Body Control Module (BCM) Reflash Sequence

Enter bulletin number M1644 in Event Comments.

Figure 1. External Power Adapter

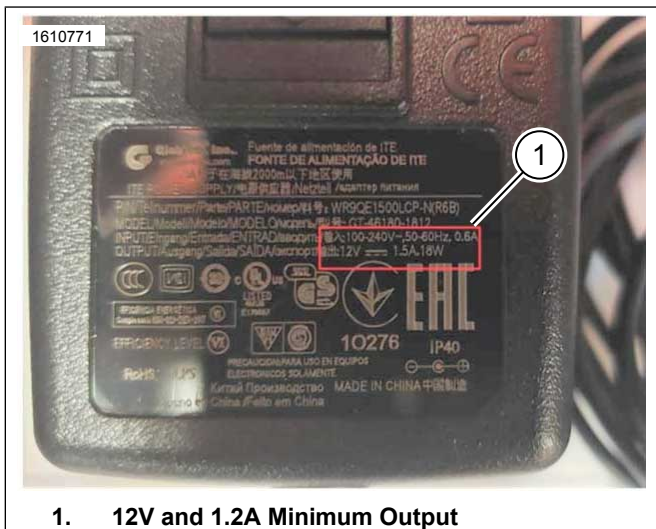
2. Connect TL-3 to vehicle.
3. Connect external power to TL-3 using appropriate power supply providing at least:
 - a. 12 V
 - b. 1.2 A
4. Place vehicle in Accessory mode.
 - a. Press and hold trip button 5 seconds.
5. Open DT II program and establish communication with vehicle.
6. Proceed to reflash BCM and follow on-screen directions.

1. 12V and 1.2A Minimum Output
